Re: FortisBC Energy Inc. (FEI)

Application for a Certificate of Public Convenience and Necessity (CPCN) for the Tilbury Liquefied Natural Gas (LNG) Storage Expansion (TLSE) Project (Application)

Response to the Residential Consumer Intervener Association (RCIA) Information Request (IR) No. 1

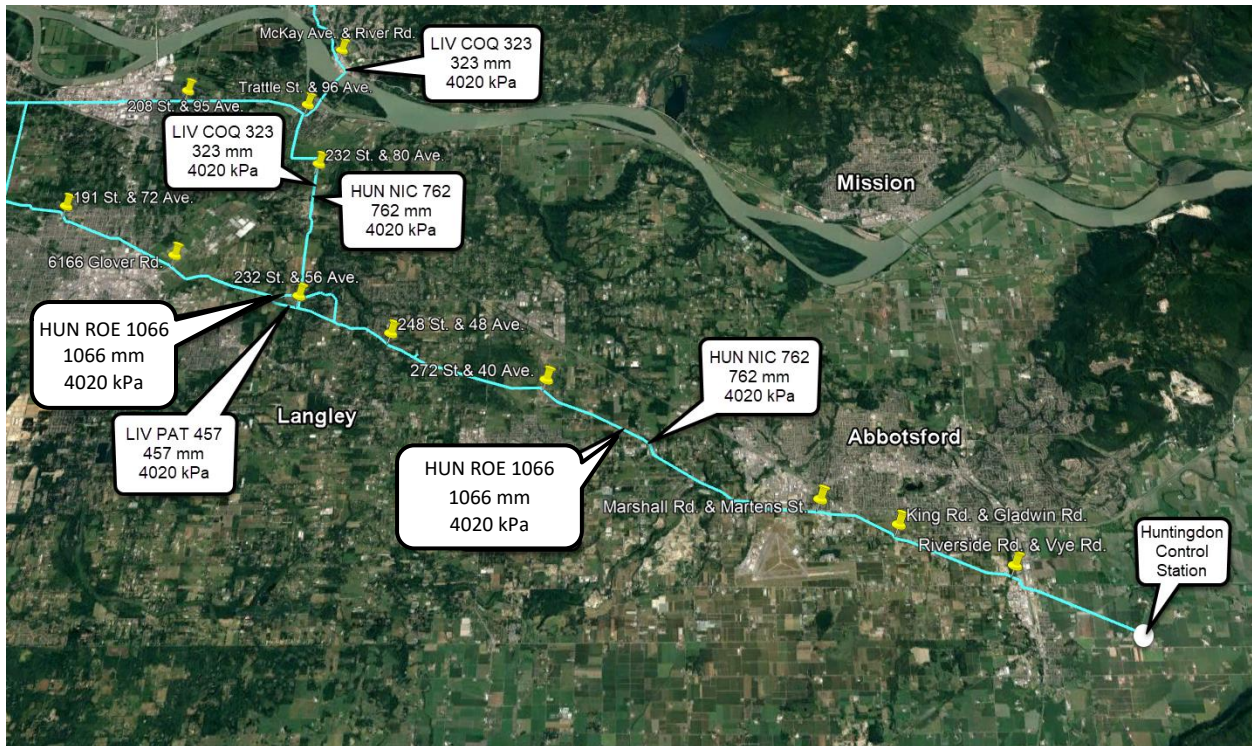
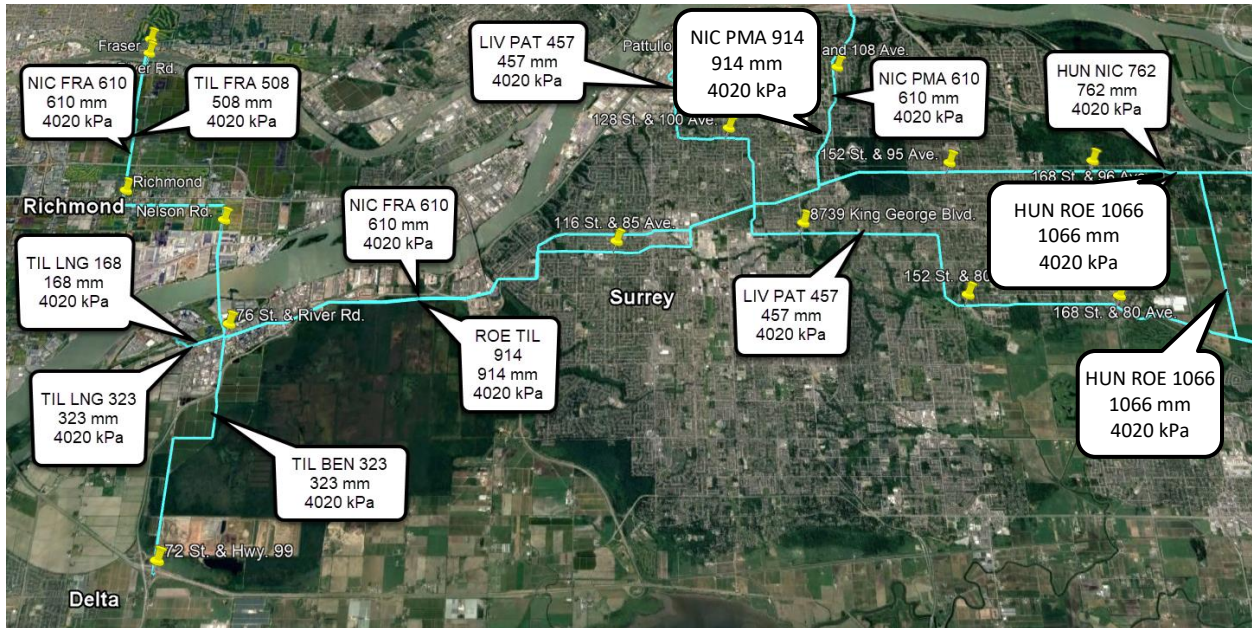
3.1 Provide a map showing the Coastal Transmission System pipelines and gate stations, including pipe diameters and maximum operating pressures.

The following maps show portions of the CTS, including FEI’s gate stations (yellow pin markers), pipe diameter, and maximum operating pressure¹ (MOP) for each transmission pipeline. Note that in some cases, pipelines run parallel to each other in the same right-of-way and may appear as a single line on the schematic. In these cases, both pipelines are labelled; for example, in the first schematic, the CPH COQ 914 and CPH BUR 508 pipelines run parallel from the Cape Horn Station until they diverge in Coquitlam.

¹ MOP refers to the actual current set pressure of the pipeline, and not the maximum pressure a given pipeline may operate at in accordance with the CSA Z662 standard.

Figure 3-5: Location of Rupture on the T-South Pipeline

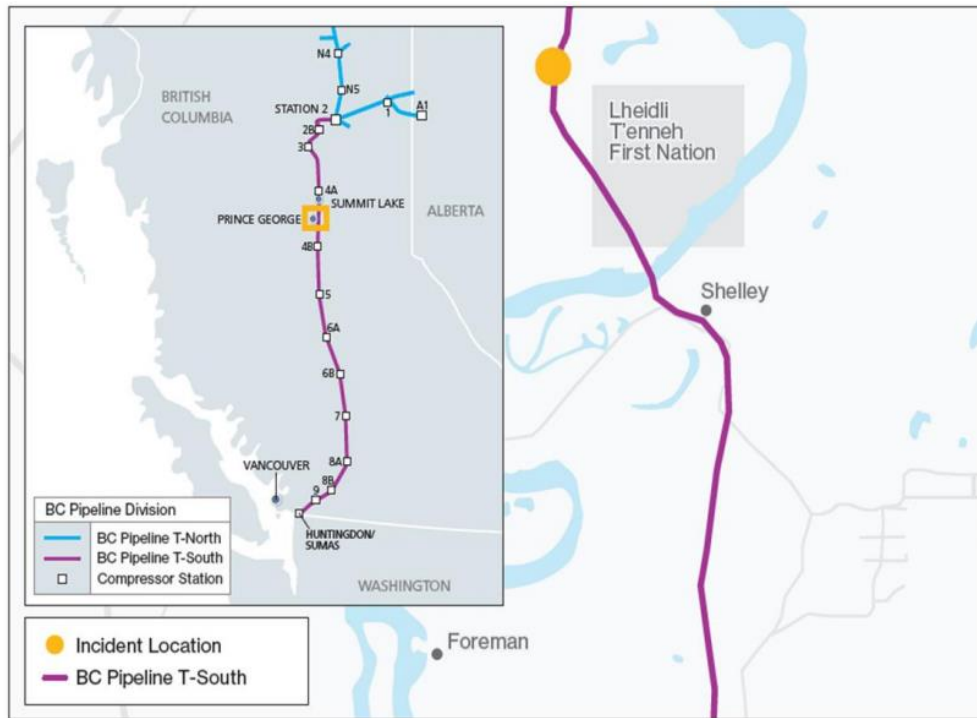
Exhibit B-1-4 p. 41: “On October 10, 2018, Westcoast declared *force majeure*, effective as of October 9, 2018. Westcoast’s *force majeure* notice indicated that service was interrupted as a result of the rupture of the NPS 36 pipeline, and that flow was restricted to zero on all delivery points on the T-South system between Compressor Station 4B and Huntingdon, as shown in Figure 3-5 above.”

The point of rupture was in the north near Station 4A of the T-South system in the vicinity of Prince George, which stopped all gas supply past Station 4B (refer to Figure 3-5 from the Application, reproduced below for convenience). However, the T-South system south of Station 4B was not physically impacted, and it allowed FEI to continue to import limited gas supply from Alberta via the Southern Crossing Pipeline, which was fed into the T-South system at Station 7 and subsequently delivered to the Huntingdon Station and into the Lower Mainland.

Figure 4-12: Lower Mainland Load Duration Curves¹⁰³

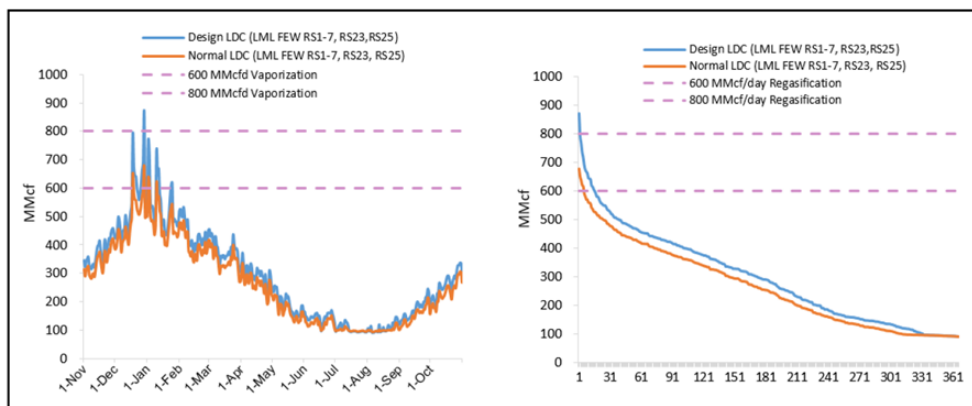
1 **22. Reference: Exhibit B-1-4 pp. 60, 117-118**

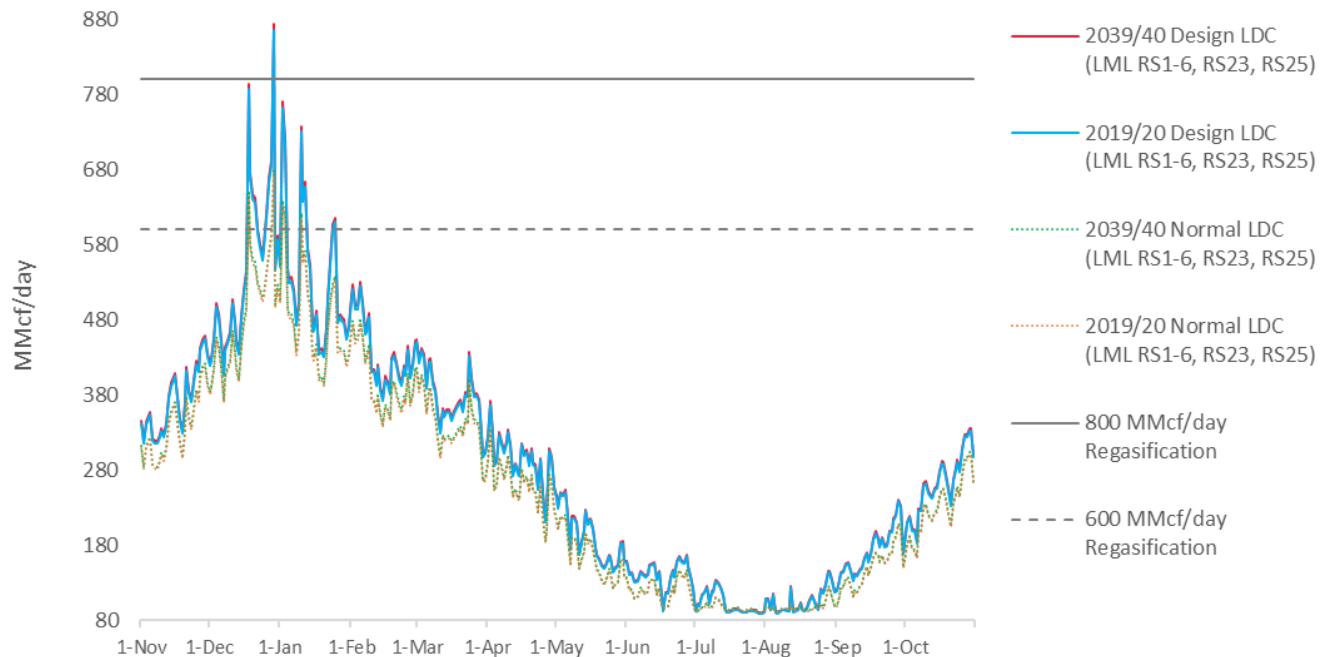
22.2 What are the expected annual growth rates in the design peak and normal winter peak?

The table below provides the number of days the Lower Mainland load is above 600 and 800 MMcf/day in the 2039/40 design and normal year, assuming current load increases by one percent per year. The 800 MMcf/day regasification meets the Lower Mainland requirements except for the peak day in the design year, while 600 MMcf/day regasification is insufficient to meet the design and normal year requirements on the colder days, if a no-flow event occurs during the December to February period.

Number of Days above Regasification Capacity	
	800 MMcf/day	600 MMcf/day
Design Year 2039/40	1 day	16 days
Normal Year 2039/40	0 day	5 days
Design Year 2019/20	1 day	15 days
Normal Year 2019/20	0 day	5 days

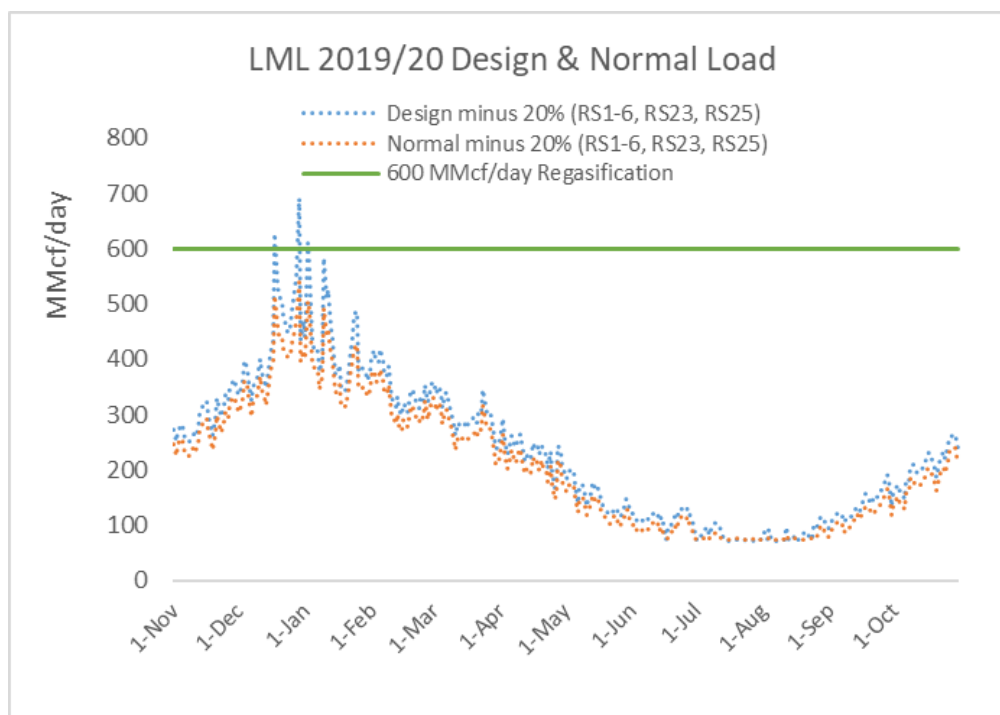
22.5 Overlay design and normal load duration curves on Figure 4-12 assuming customers voluntarily curtail their consumption by 20%.

Assuming customers voluntarily curtail their consumption by 20 percent, 600 MMcf/day regasification would be sufficient to meet the 2019/20 normal load requirements and would be able to meet the 2019/20 design load requirements, except for the three coldest days. This has been illustrated in the below figure. However, FEI emphasizes that, as discussed in the responses to BCUC IR1 13.3 and 19.2, voluntary curtailment is not a resiliency tool that FEI can rely on.
